Design Review Committee Meeting

700 Doug Davis Drive
Hapeville, GA 30354

October 20, 2021 6:00 PM

**DEPARTMENT OF PLANNING AND ZONING
PLANNER'S REPORT**

EXISTING
ELEVATIONS

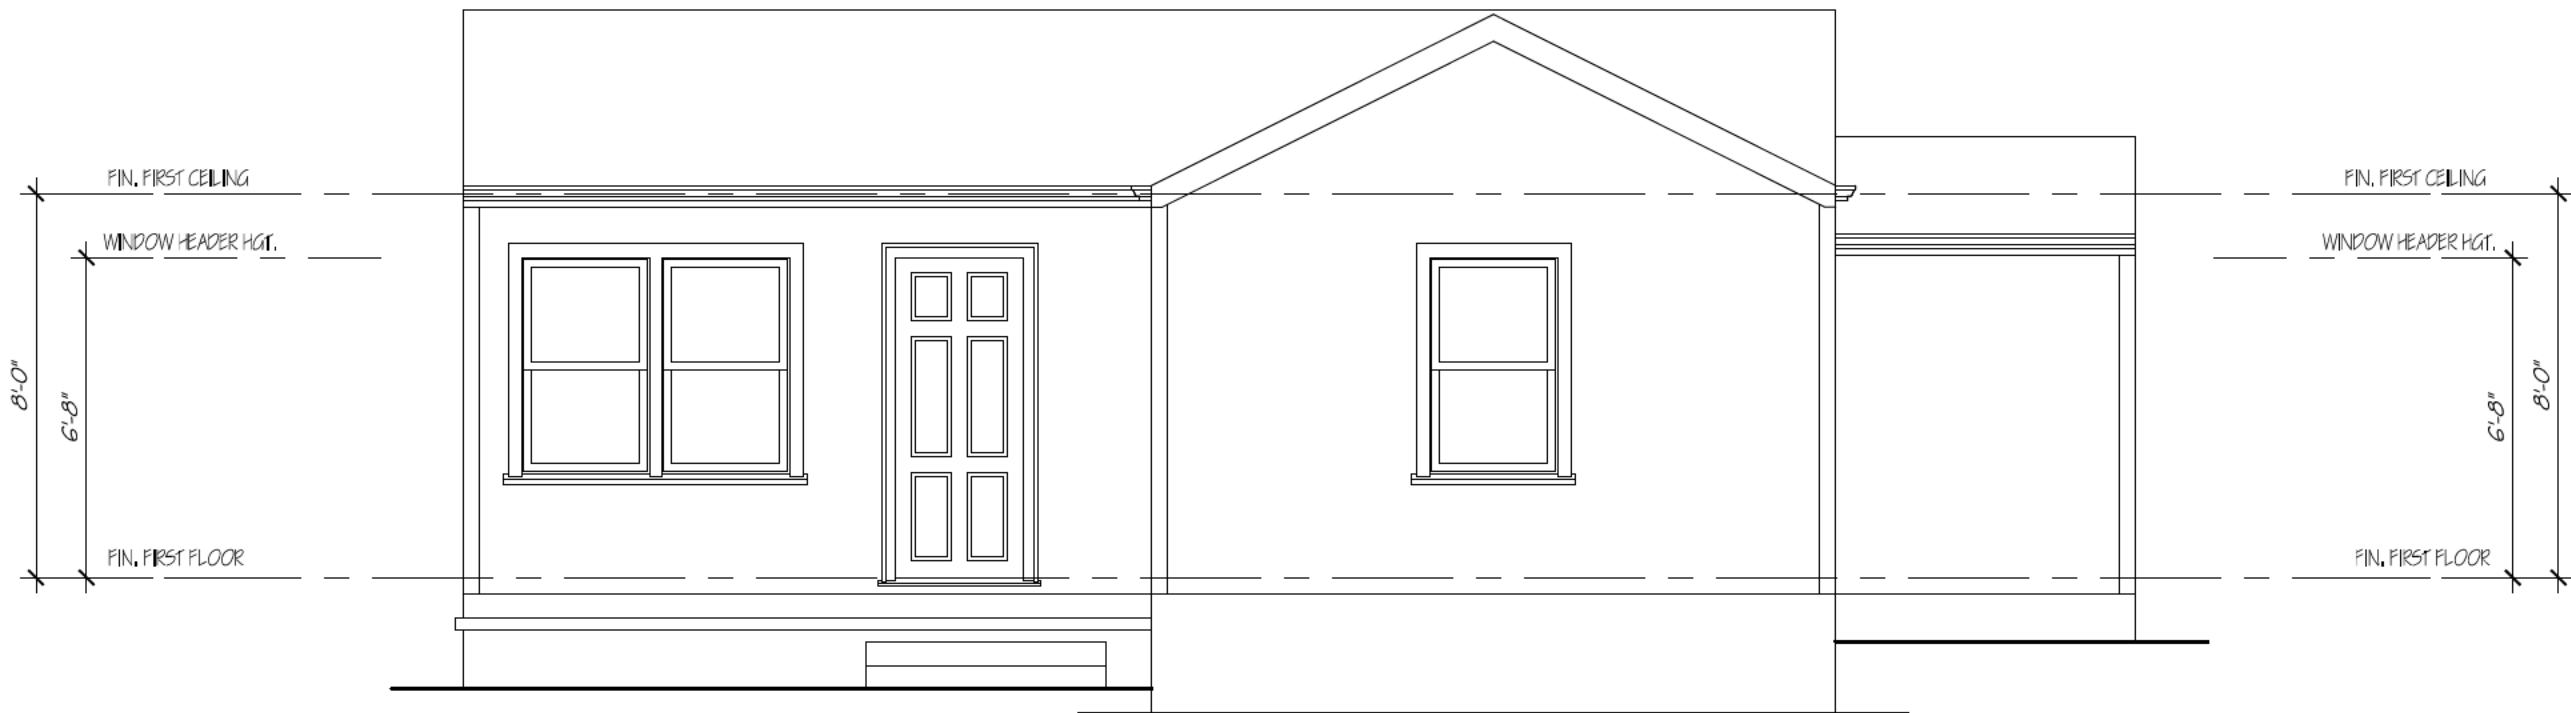
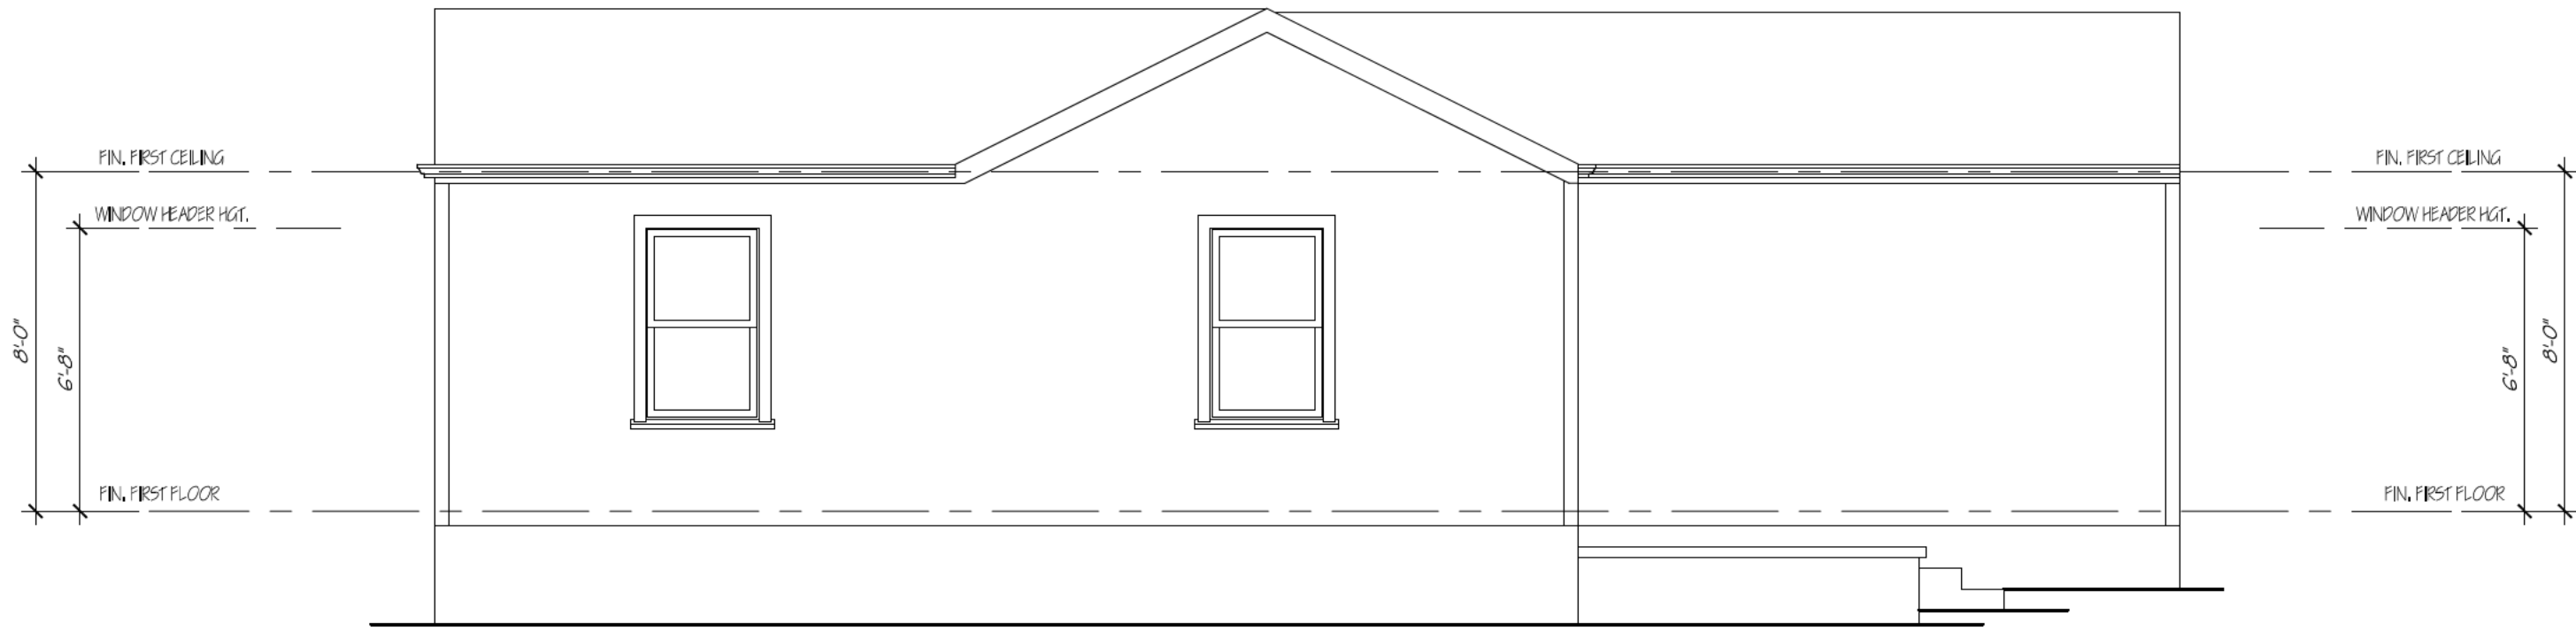
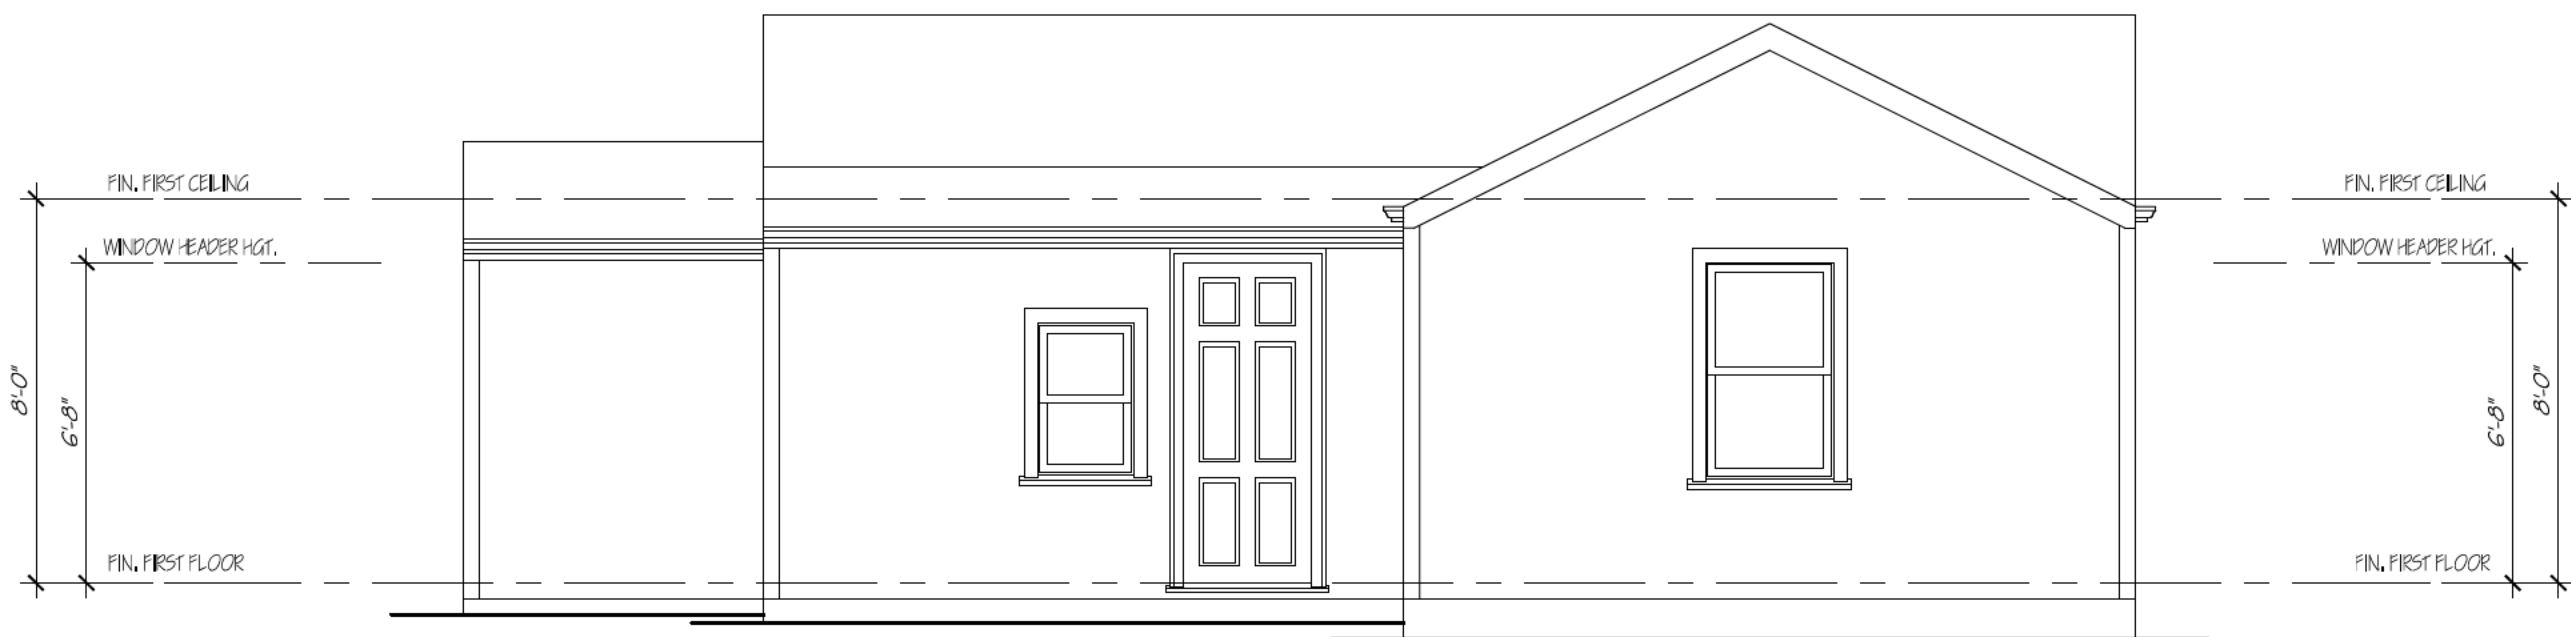
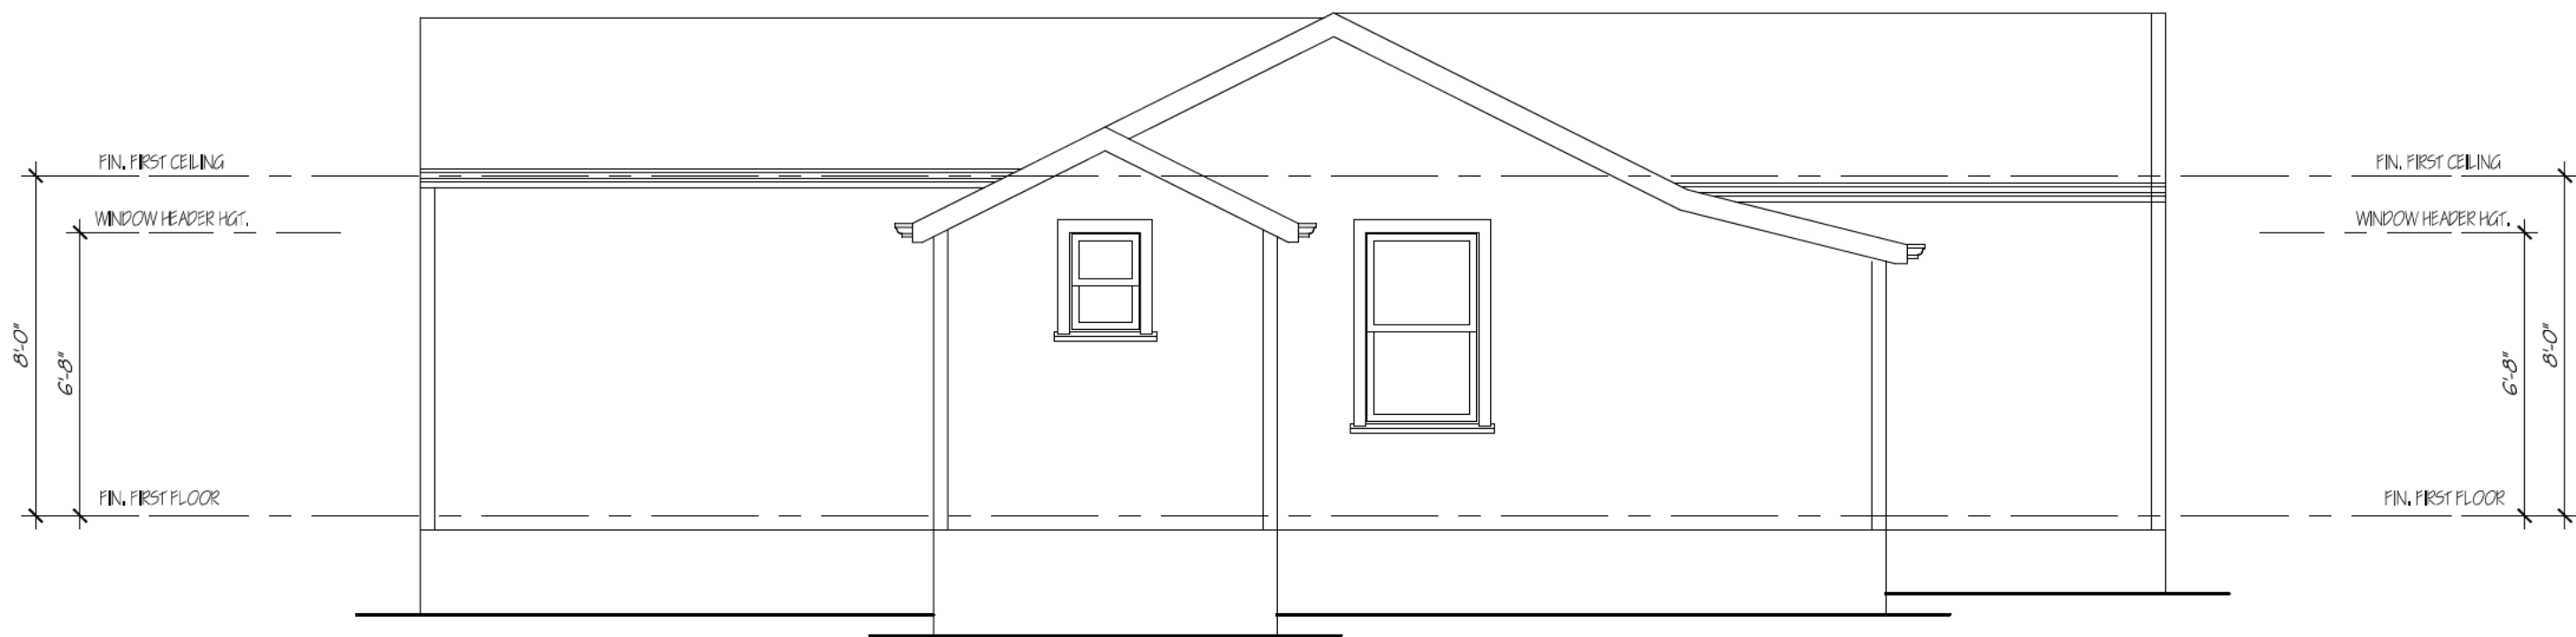
Note: the front elevation appears to be changed with the addition of front gable and higher roof pitch, addition of twin window, front porch (A0). The existing plans show a side gable. Applicant should verify this is correct.

4 TYPICAL WINDOW UNIT
A4 SCALE: 1/2" = 1'-0"

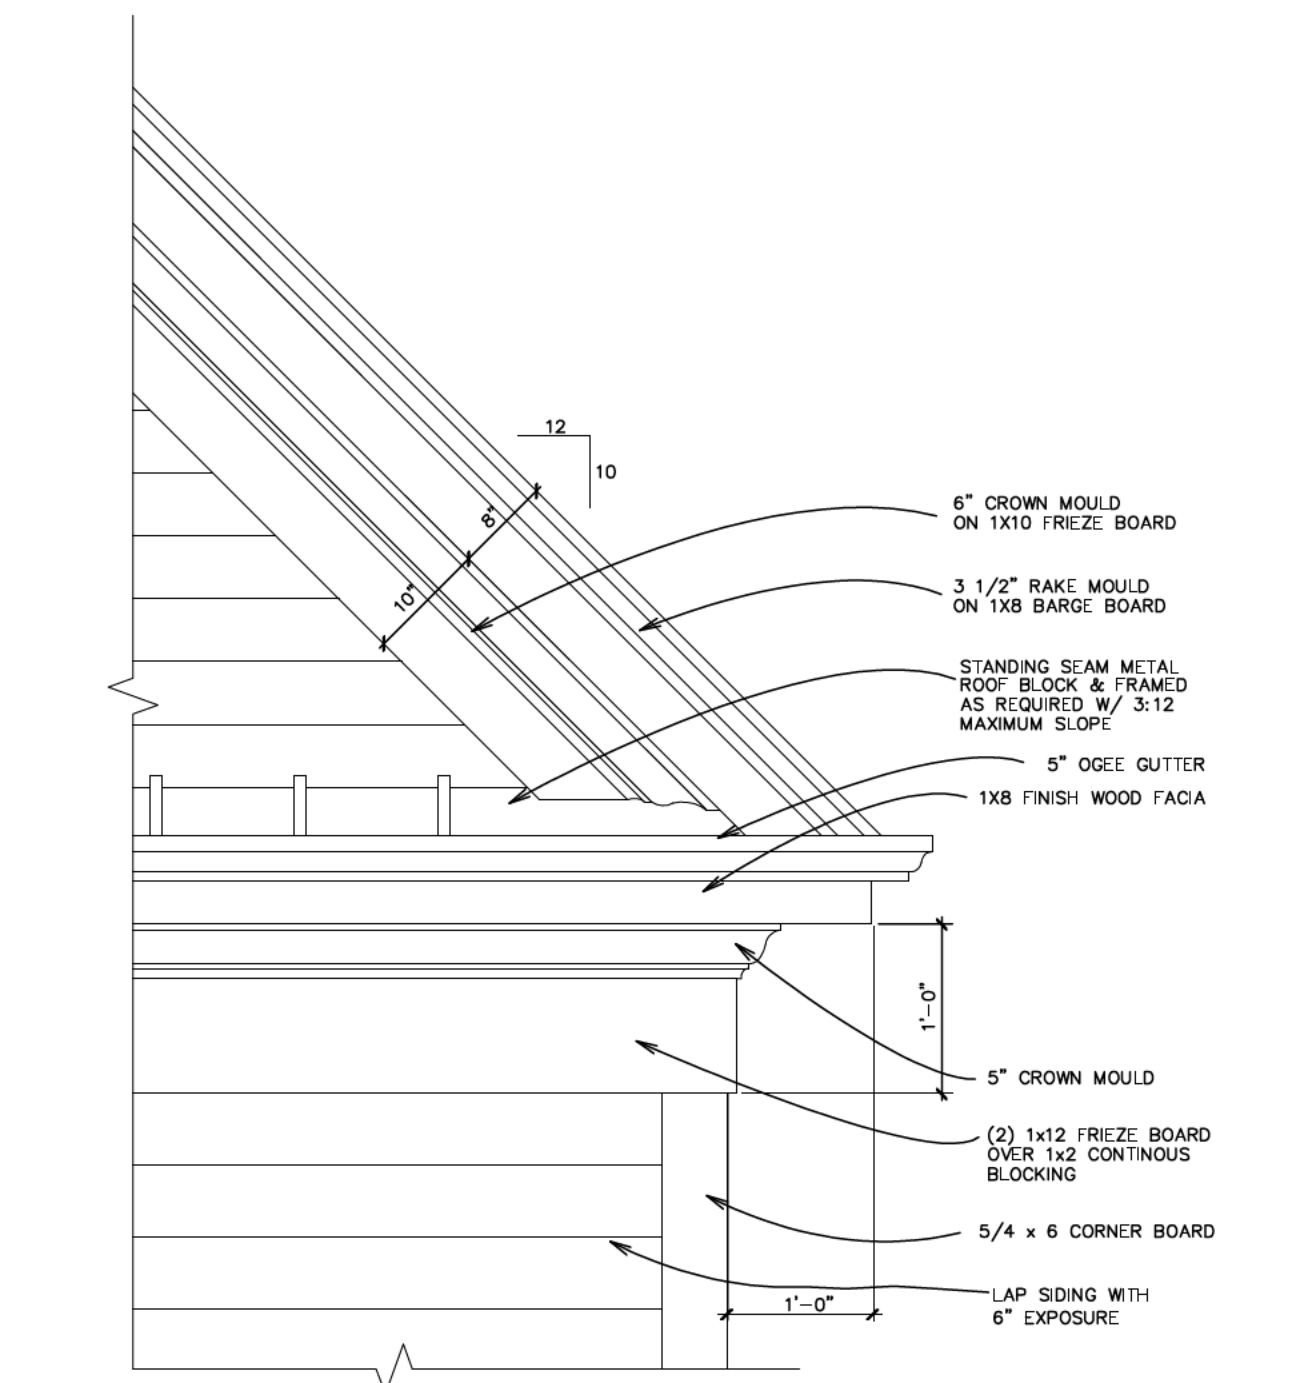
STAFF COMMENT: Window detail (recess, trim, sill) not provided. Must meet standards.
